ATC Methodology Technical Workshop

May 5, 2005

Transmission Business Line

AMM and Non Firm Impacts to ATC A Visual Guide to Evolution (Spring and Summer)

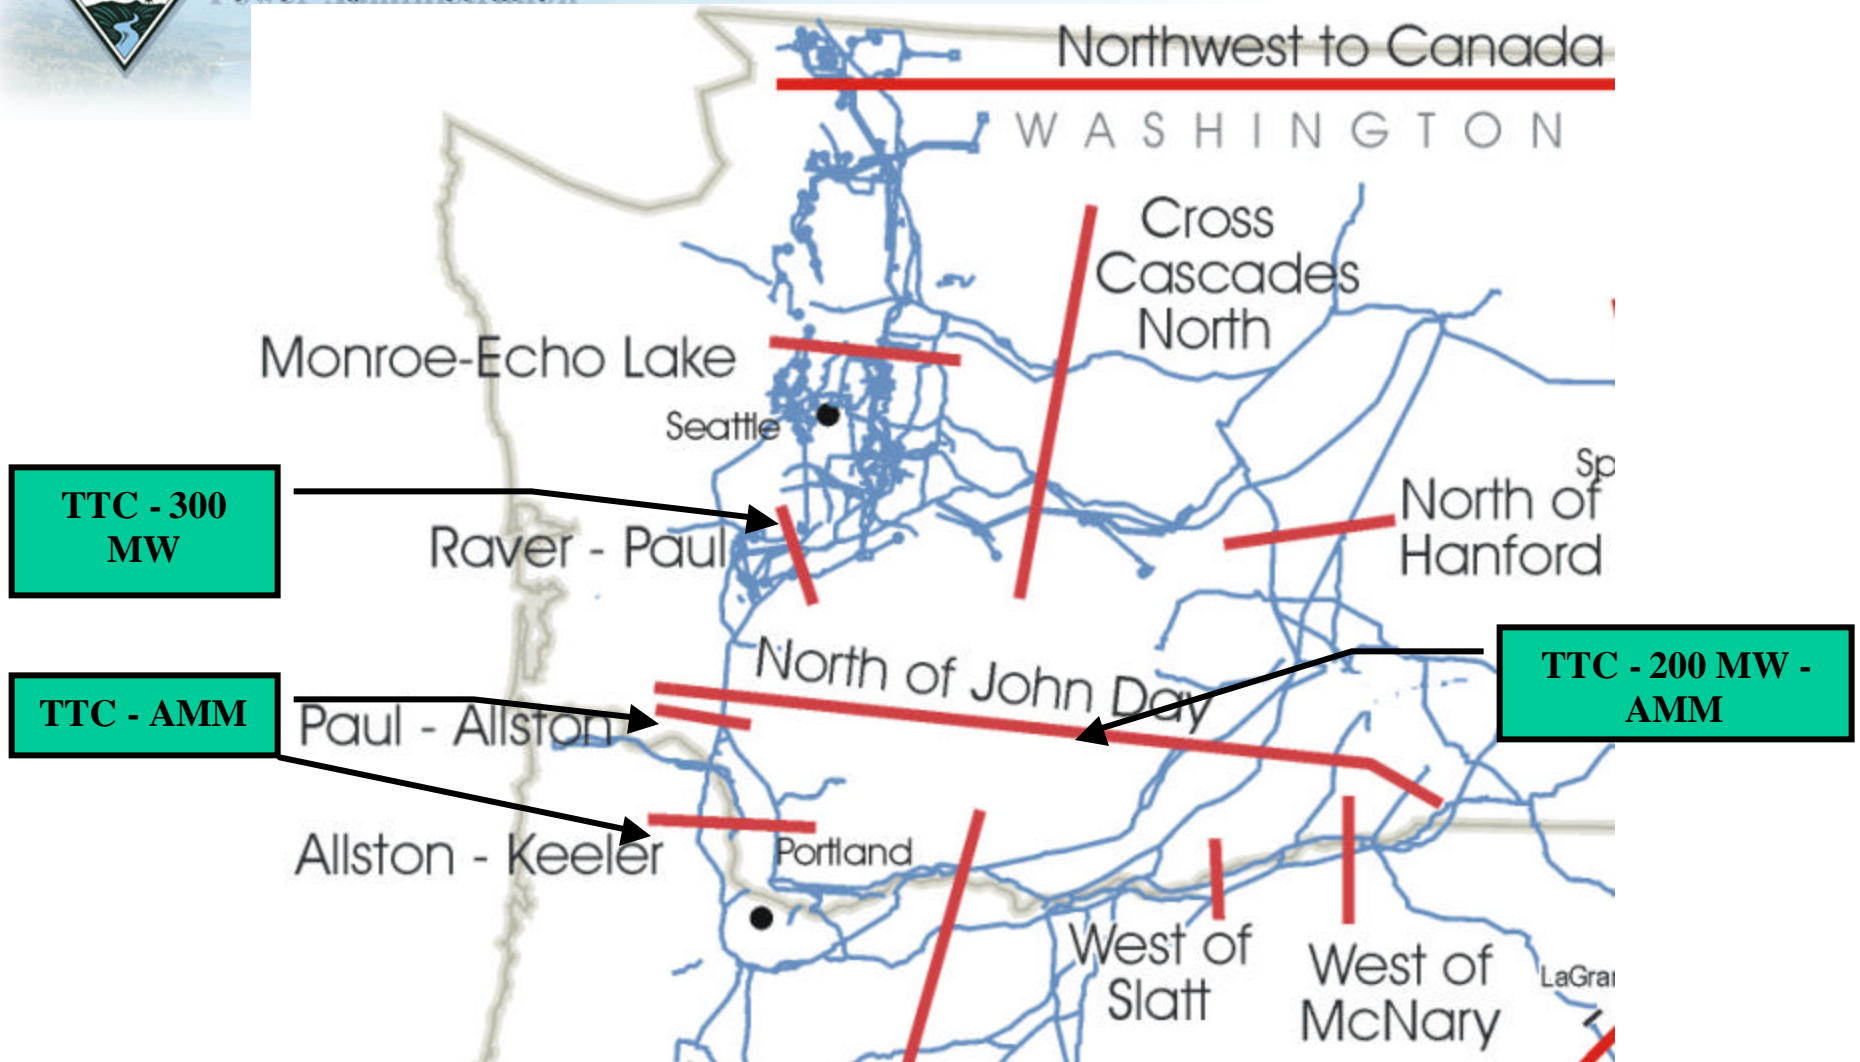
- **How much ATC will TBL gain by reducing AMM on these 3 flowgates?**
- **Will AMM shrink in the future?**

- Cannot say for certain
- Tendency will be for AMM to increase because contract accounting flows tend to exceed planning flows
 - Increased sales should increase contract accounting flows more than planning flows (due to full netting in planning base case)
- AMM will be recalculated and evaluated with each annual/semi-annual base case update

August Planning ATC Basecase relative to Nomogram North of John Day vs COI+NW/Sierra + PDCI 2005 Summer N-S

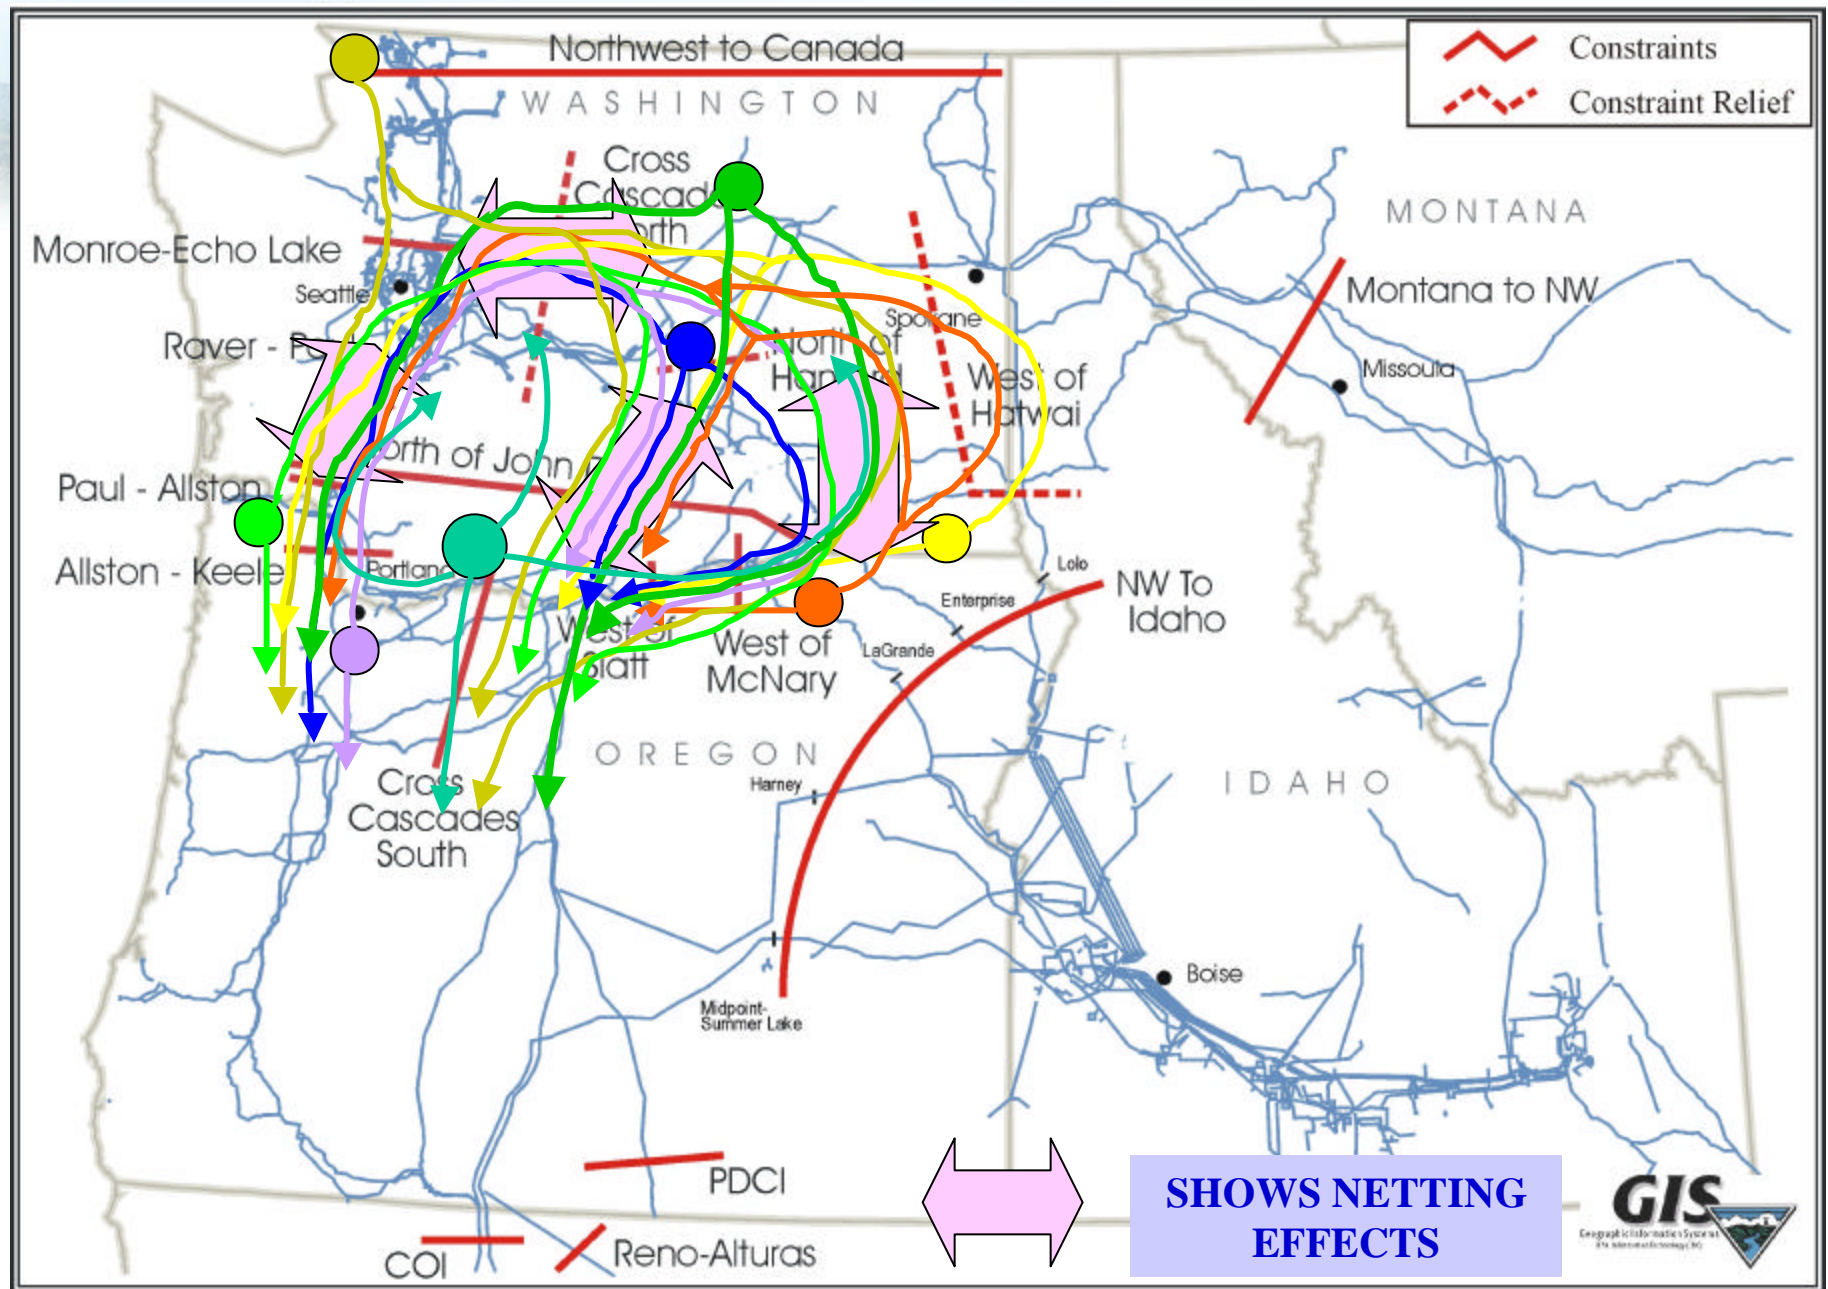
- **Does “Planning ATC” accommodate an adequate range of generation dispatches?**

- Planning ATC is based on a single dispatch
- Generation dispatch flexibility is significantly preserved through AMM, TRM, peak hour planning, and other conservative assumptions in the methodology
- Dispatch flexibility involves a trade-off between costs and benefits
 - Constraint management systems provide cost and benefit signals (e.g., CAISO)
 - Signals are obscured on TBL system
- Dispatch sensitivities can provide information on system flexibility to accommodate alternative hydro dispatches
